Certificate of Appropriateness

| Property | 2457 N. TERRACE AV. |
| Date issued | 6/3/2019 PTS ID 114756 COA: alter porches and landscaping |

TRUE NORTH
 PLAN NORTH
PROPOSED SITE PLAN
 1/8" = 1'-0"

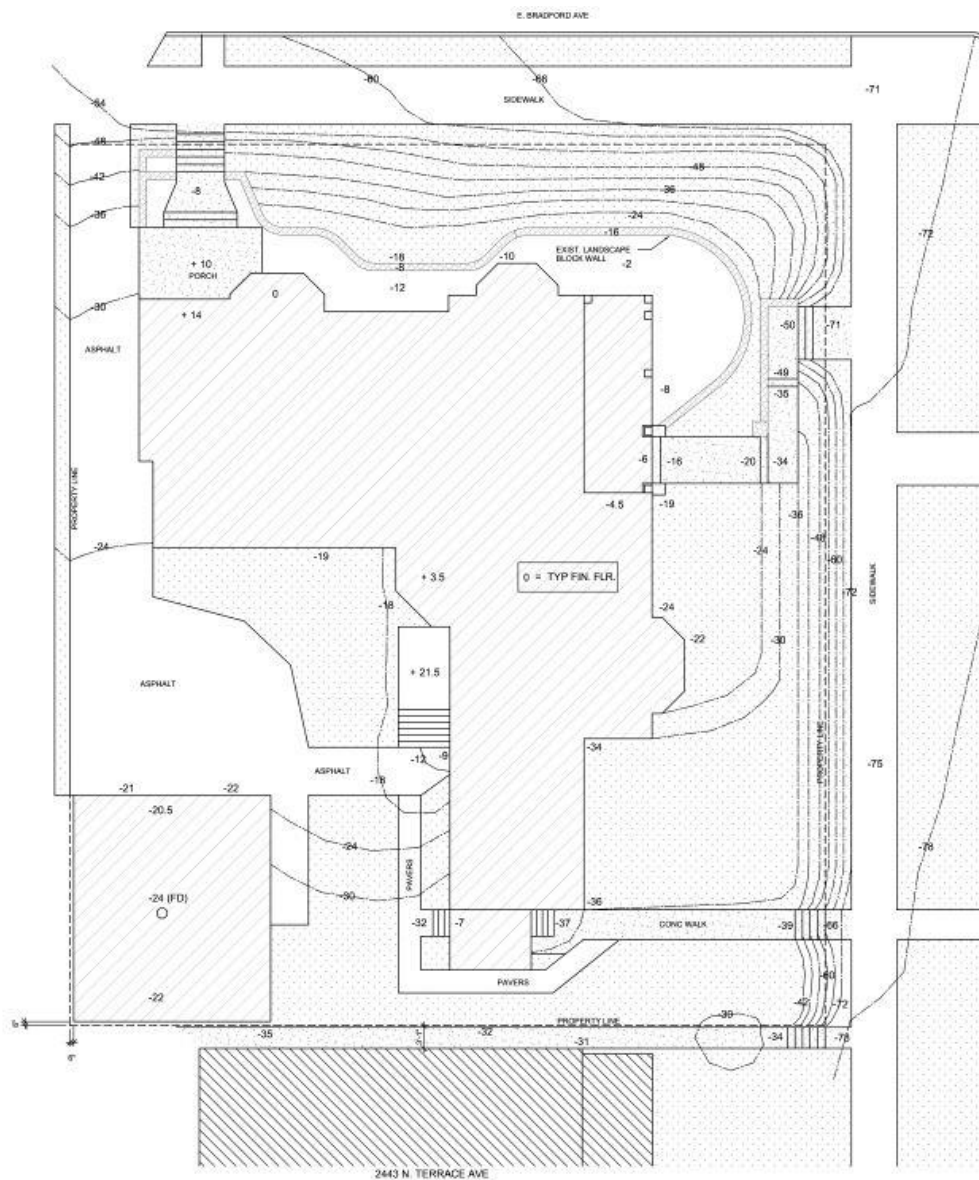
Proposed site plan with amendments clouded

PROPOSED SITE GRADE PLAN
 1/8" = 1'-0"

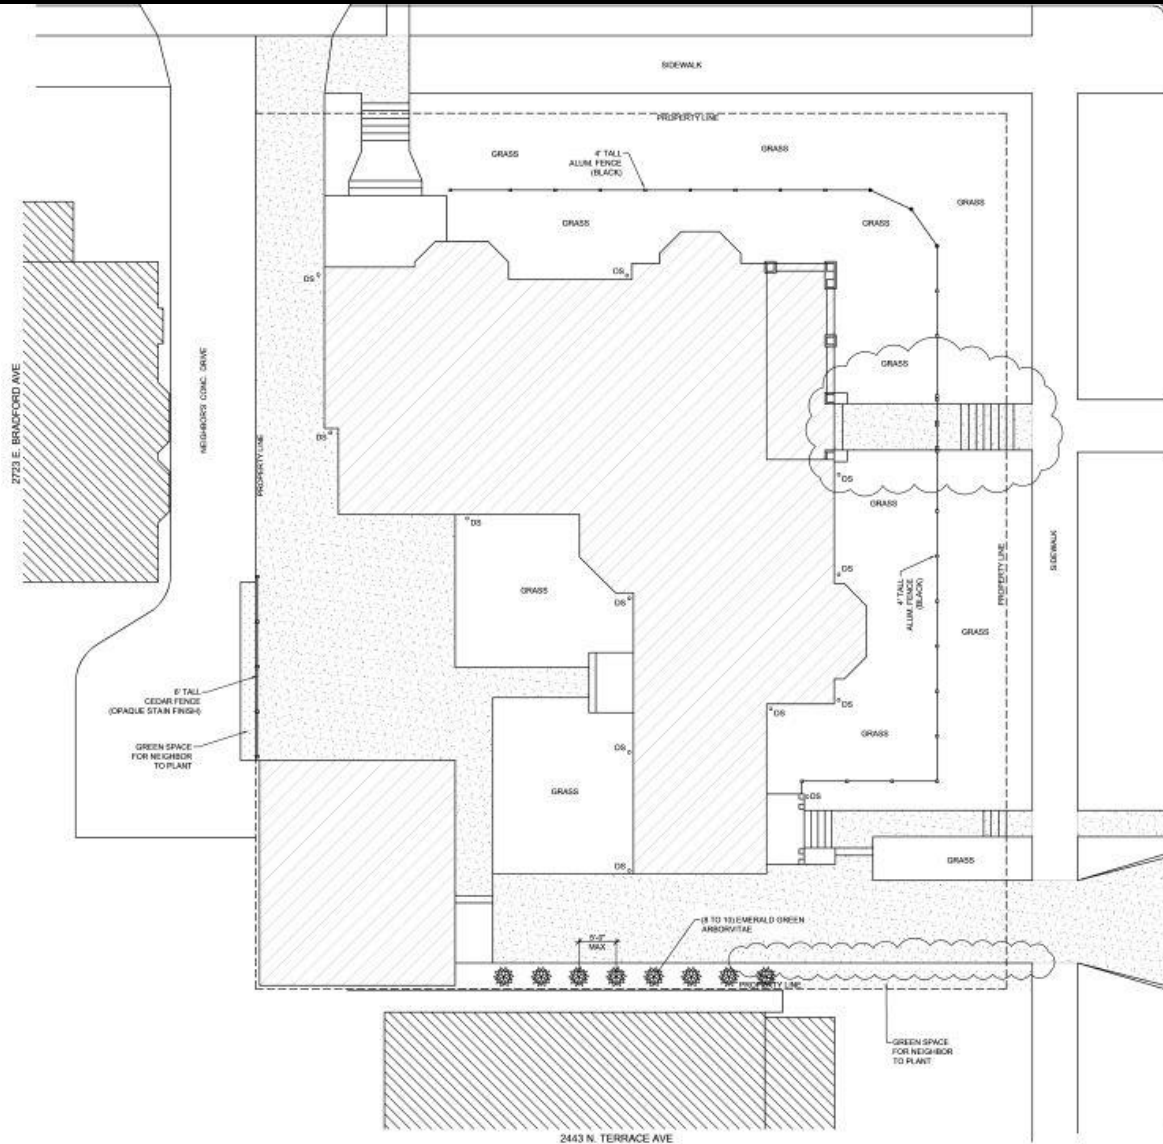
Proposed site grade plan indicating revised grade elevations and eliminated concrete retaining wall (clouded) at the southern property line

PROPOSED EAST ELEVATION

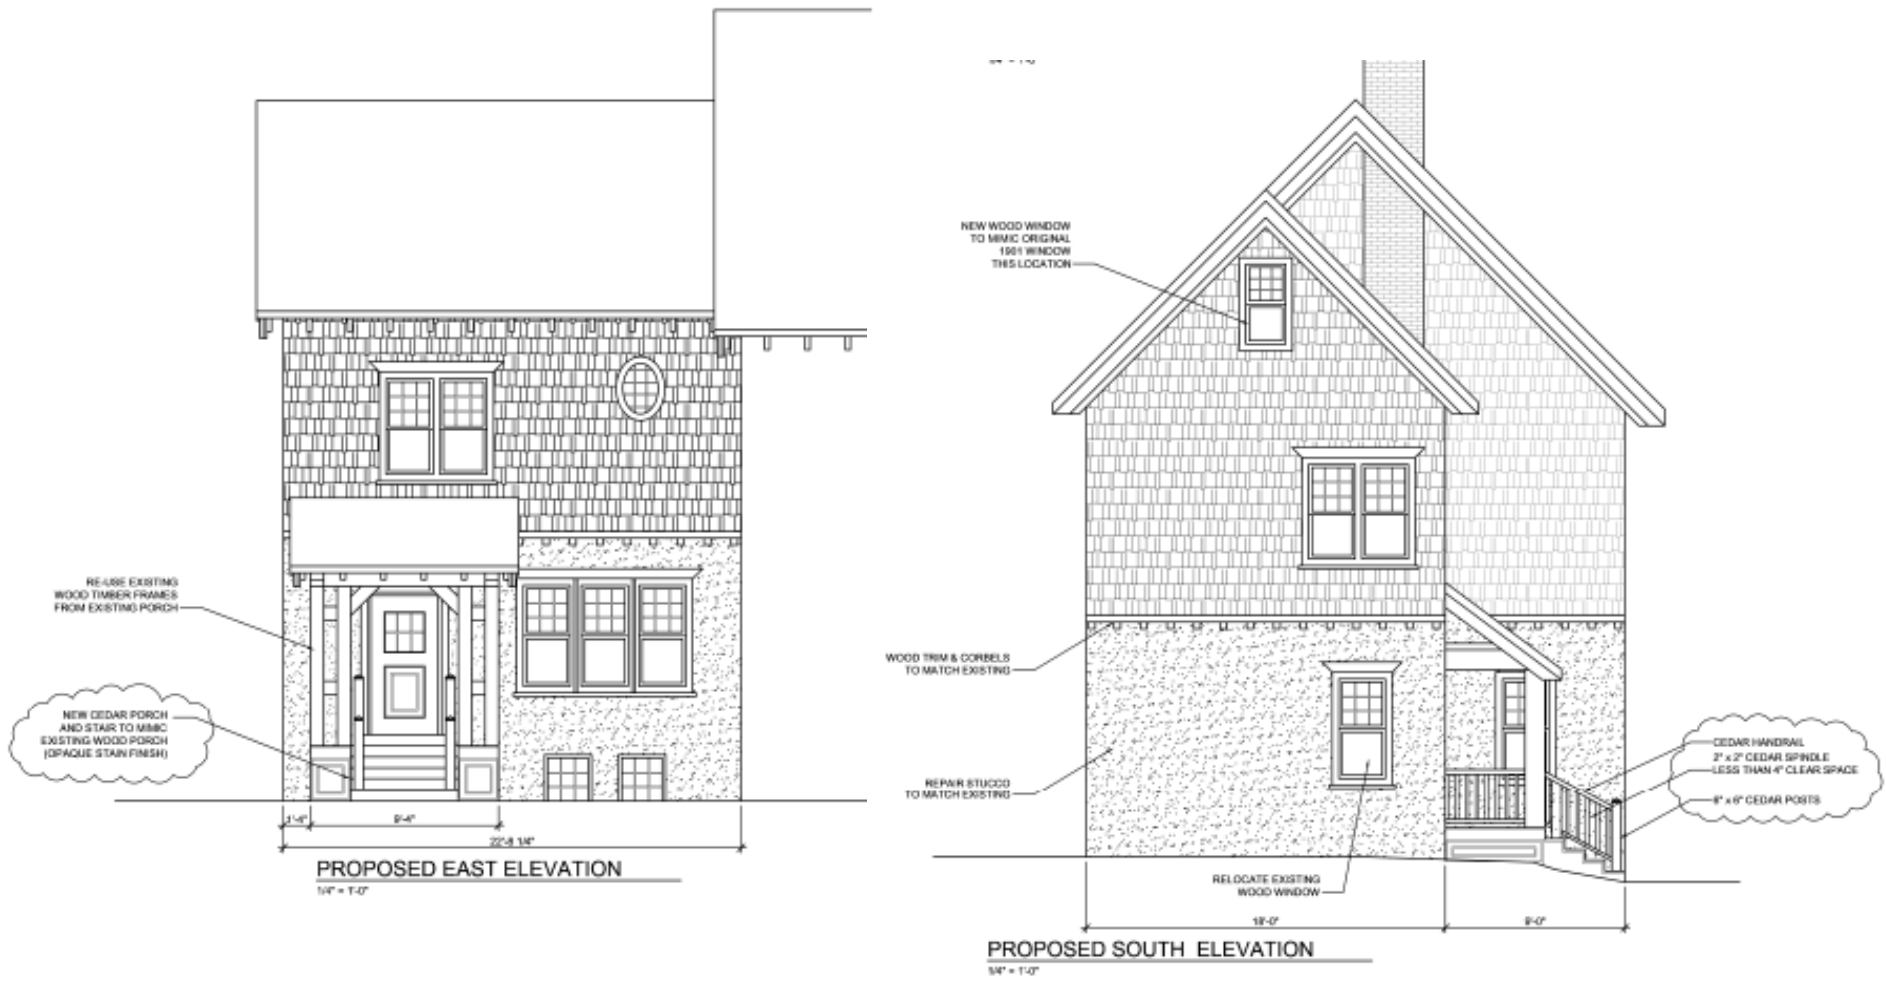
Existing and proposed east elevations indicating the construction of a new cedar porch designed to match existing conditions

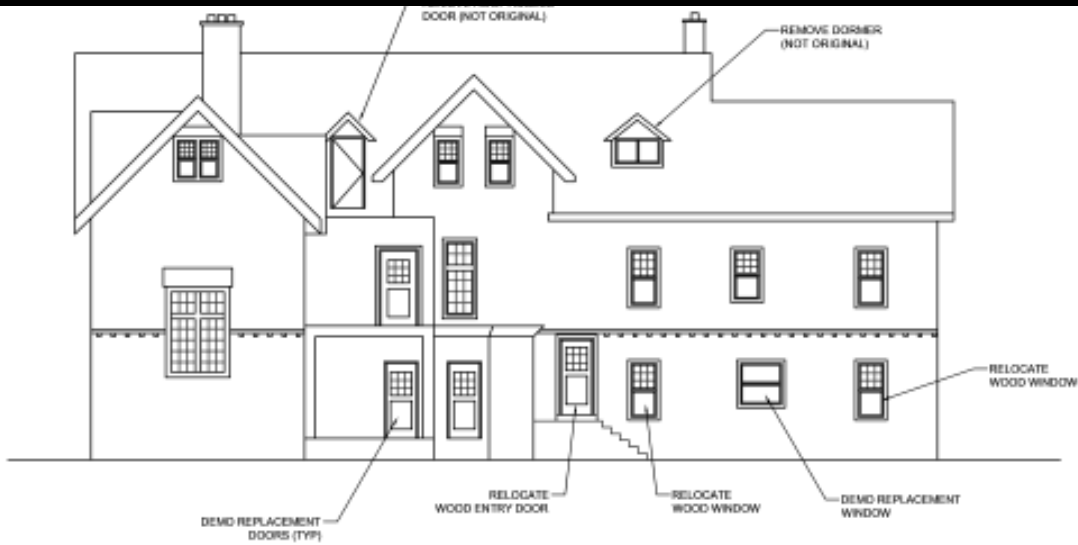
REMOVE WOOD LAP SIDING (NOT ORIGINAL)

REMOVE WROUGHT IRON HAND RAILS - RUSTED THRU (NOT ORIGINAL)

RESTORE ORIGINAL STUCCO FINISH

NEW CEDAR PORCH AND HANDRAIL TO MIMIC EXISTING WOOD PORCH (OPAQUE STAIN FINISH)

Existing and proposed north elevations indicating the removal of non-original wood siding and the restoration of original stucco finish. Elevations also indicate the replacement of wrought iron handrails with cedar handrails to match existing porch.

PROPOSED WEST ELEVATION

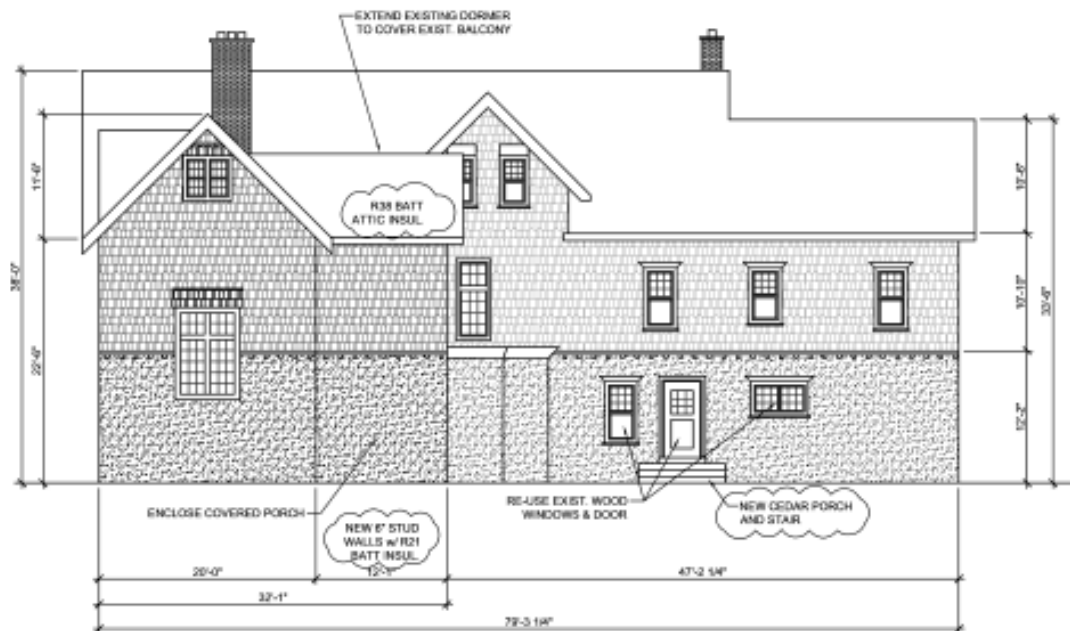
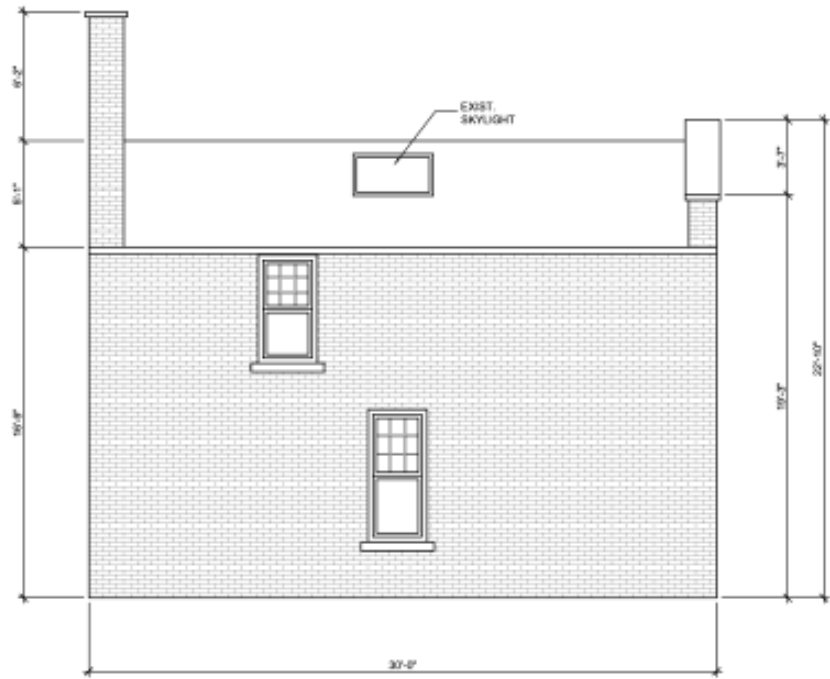
Existing and proposed west elevations indicating the construction of a new cedar porch and stair

NEW CEDAR PORCH AND STAIR

COACH HOUSE
PROPOSED EAST ELEVATION
1/4" = 1'-0"

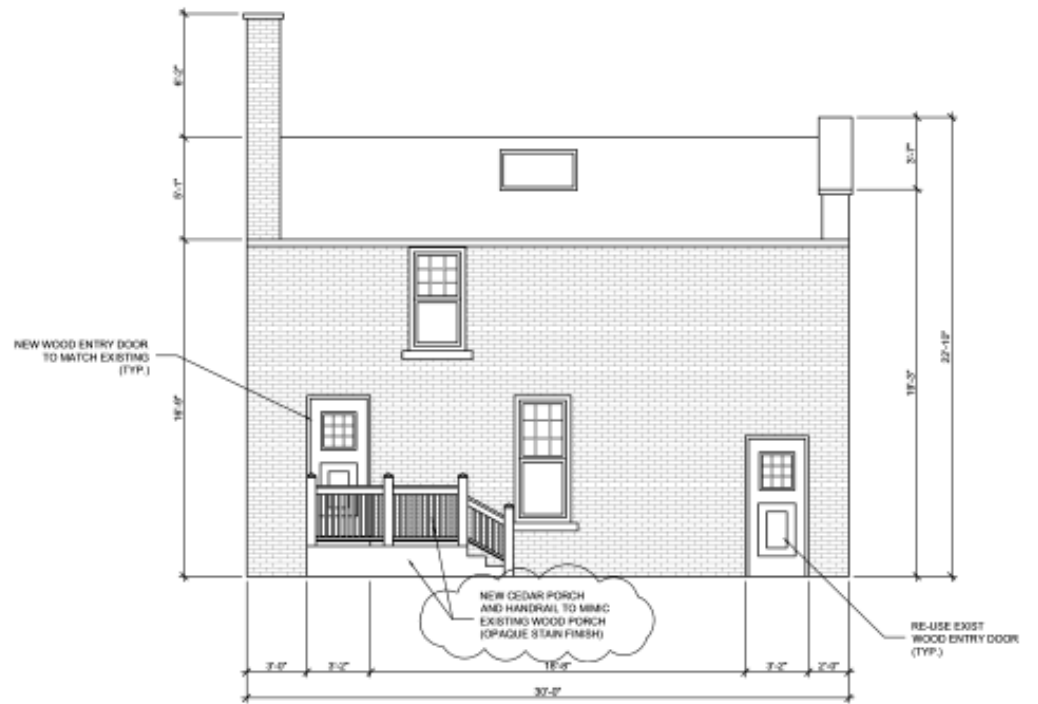
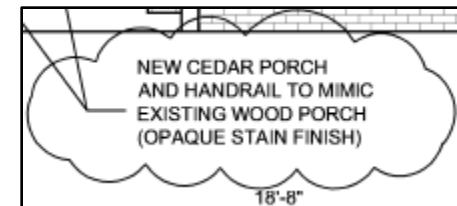
Existing and proposed eastern elevations of the coach house indicating the construction of a new cedar porch
